Addendum No. 3
January 24, 2023

Project: Baltic High School Addition
Baltic, South Dakota
Arch Project No. 2957

Architect: Architecture Incorporated

5) SHEET 4.10-2G – SECOND FLOOR PLAN – AREA G

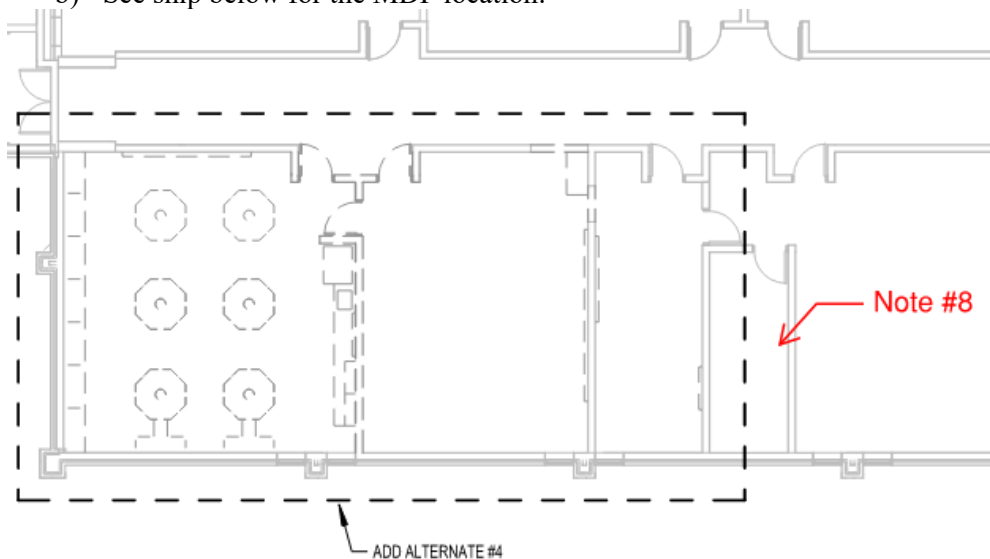
- a) Provide 3 5/8” stud framing with one layer of 5/8” gypsum board (one side) in the NW corner of Mechanical Penthouse G300. Install along Grid Fg; extend to structure above.

BALTIC HIGH SCHOOL ADDITION
SECOND FLOOR PLAN - AREA F - POWER & SIGNAL

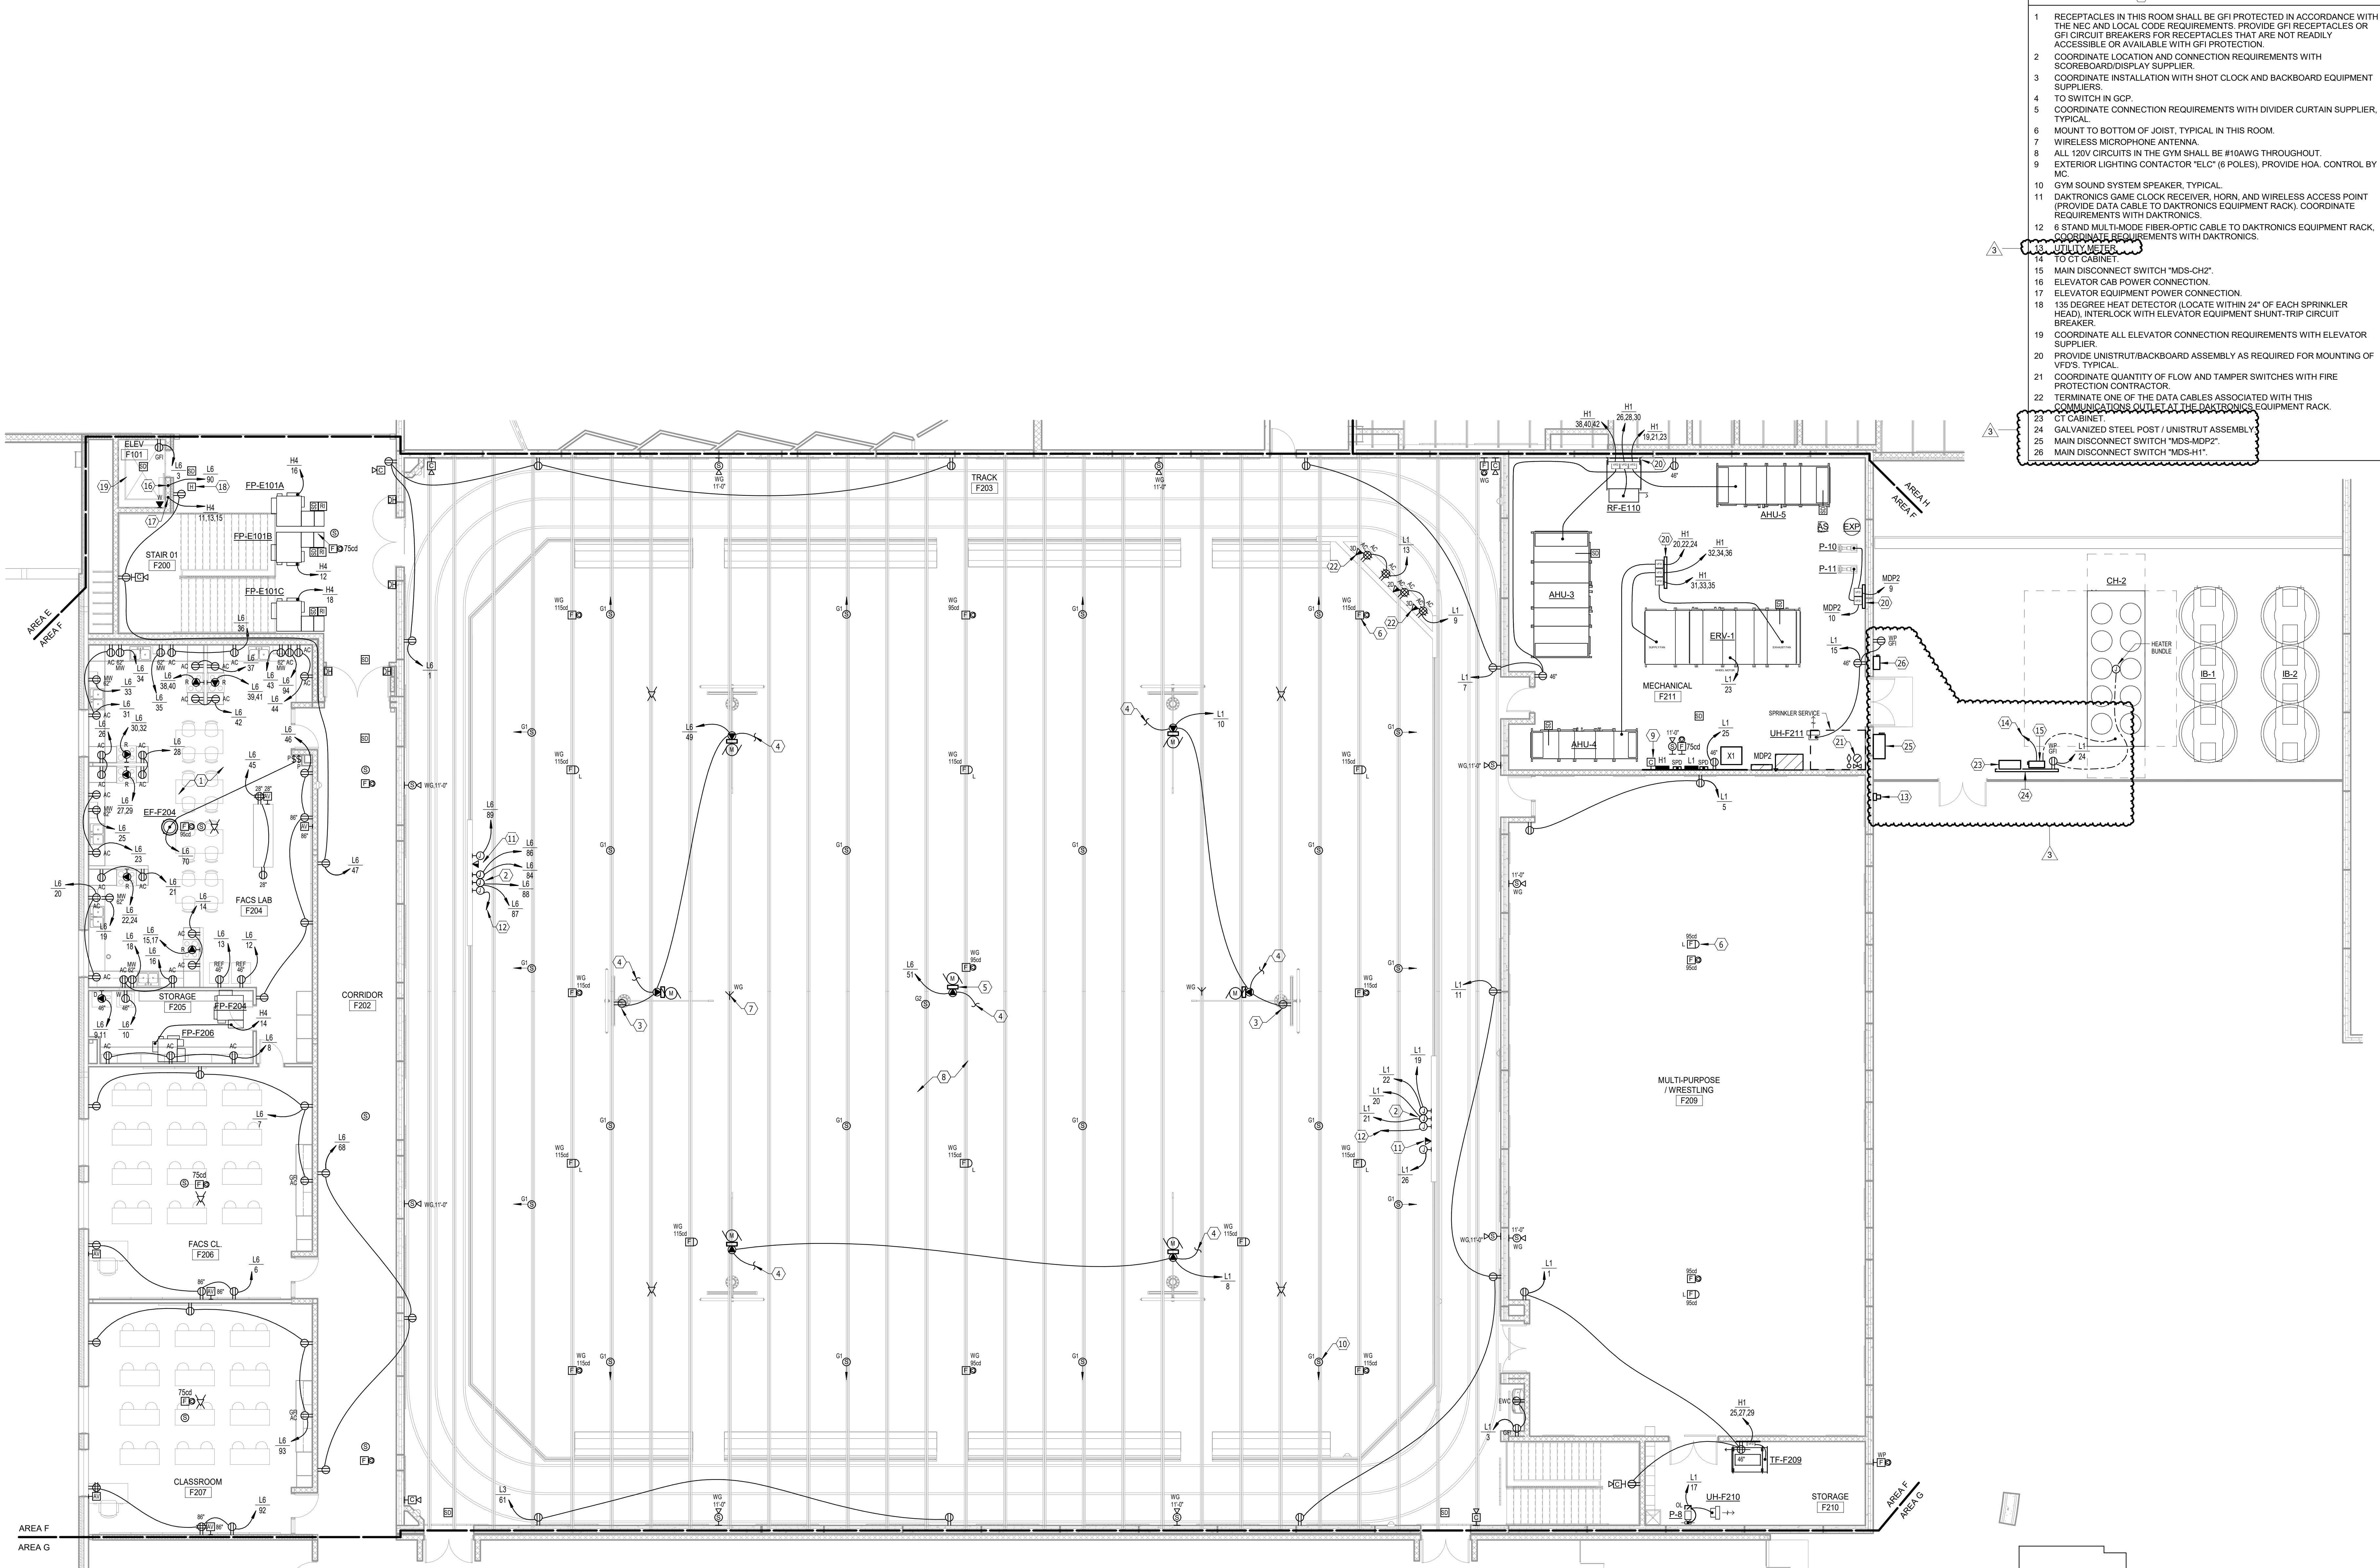
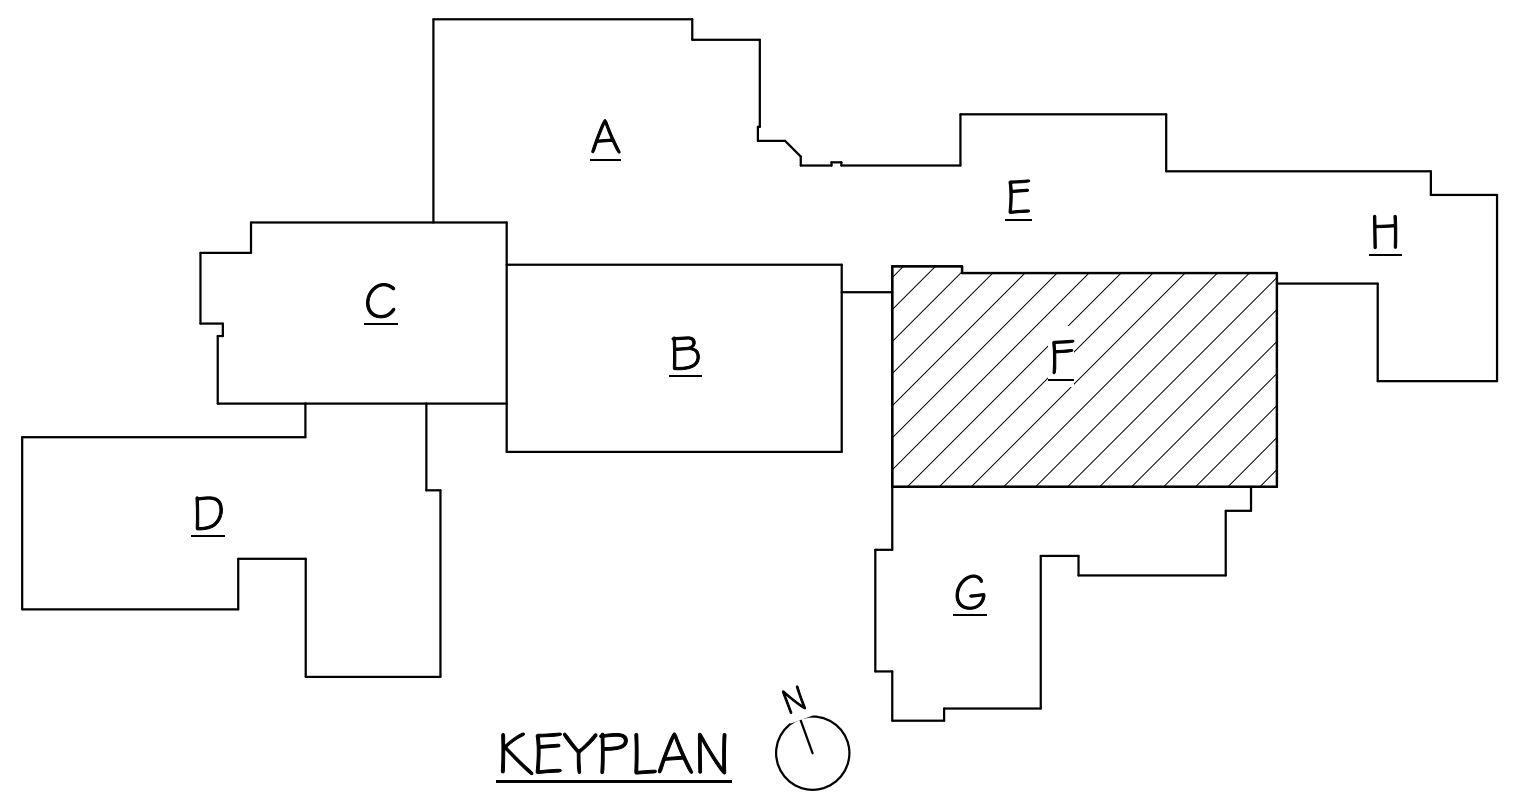
- a) Reference revised electrical drawing Sheet 9.43, revision dated 1-24-23, attached to the end of this addendum for revisions at the utility yard area.

POWER RISER DIAGRAM
NO SCALE

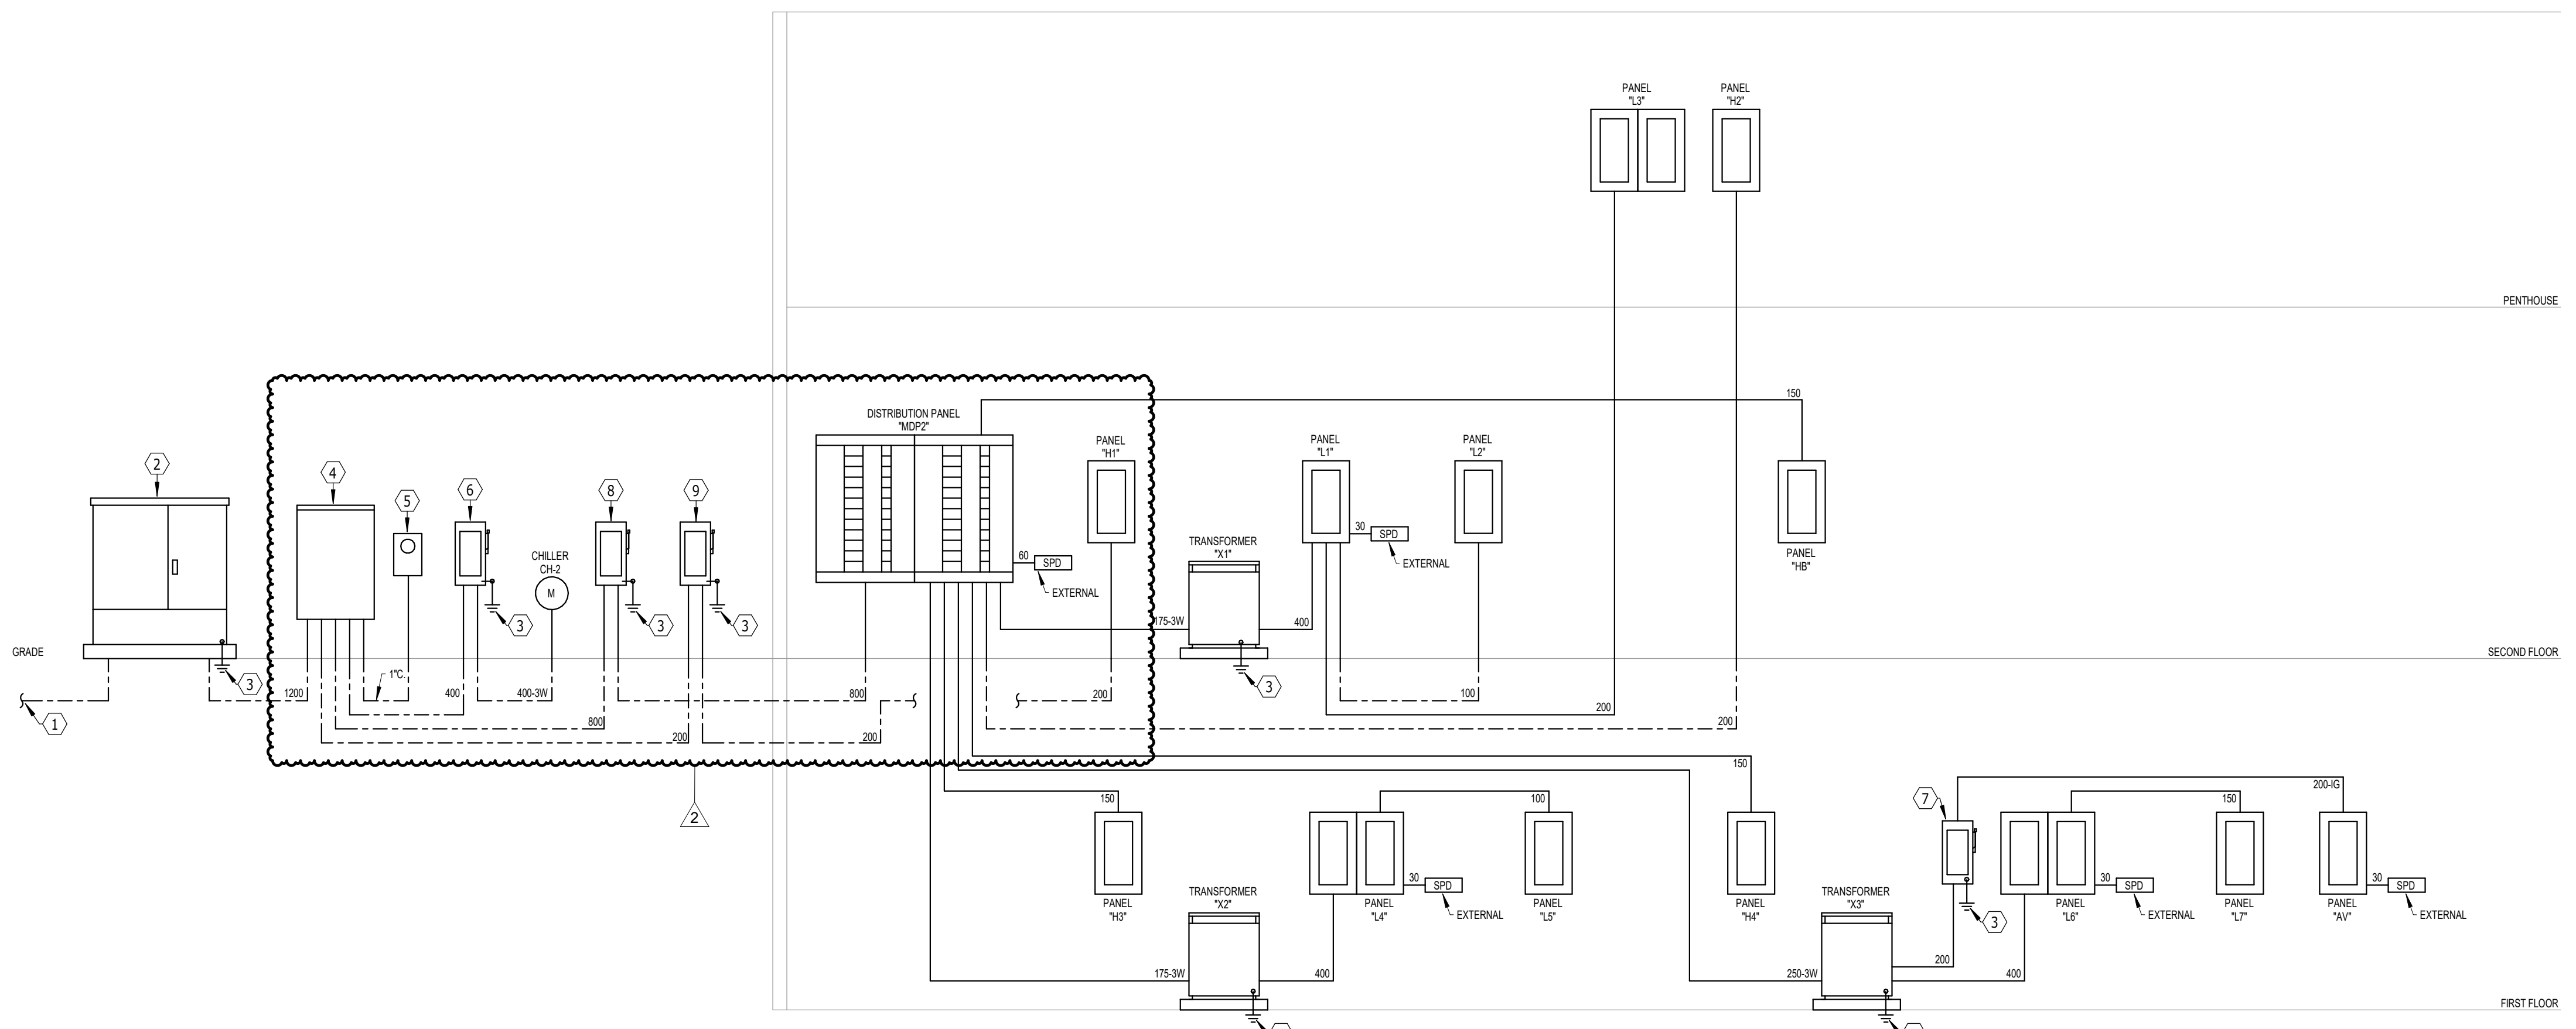
- a) Power Riser Diagram: Reference revised electrical drawing Sheet 9.50, revision dated 1-24-23, attached to the end of this addendum for revisions associated with the electrical services.

- 1 PRIMARY BY UTILITY. COORDINATE RACEWAY REQUIREMENTS WITH UTILITY.
2 TRANSFORMER BY UTILITY. PAD BY ELECTRICAL CONTRACTOR (EC).
3 GROUND IN ACCORDANCE WITH THE NEC, LOCAL CODE REQUIREMENTS, AND SPECIFICATIONS.
4 1200A CT CABINET BY EC.
5 METER BY UTILITY. METER SOCKET BY EC.
6 MAIN DISCONNECT SWITCH "MDS-CH-2", 400A/3P, NEMA 3R, FUSE AT 400A.
7 DISCONNECT SWITCH "DS-A", 200A/3P, FUSE AT 200A.
8 MAIN DISCONNECT SWITCH "MDS-MDF-2", 800A/3P, NEMA 3R, FUSE AT 800A.
9 MAIN DISCONNECT SWITCH "MDS-H1", 200A/3P, NEMA 3R, FUSE AT 200A.
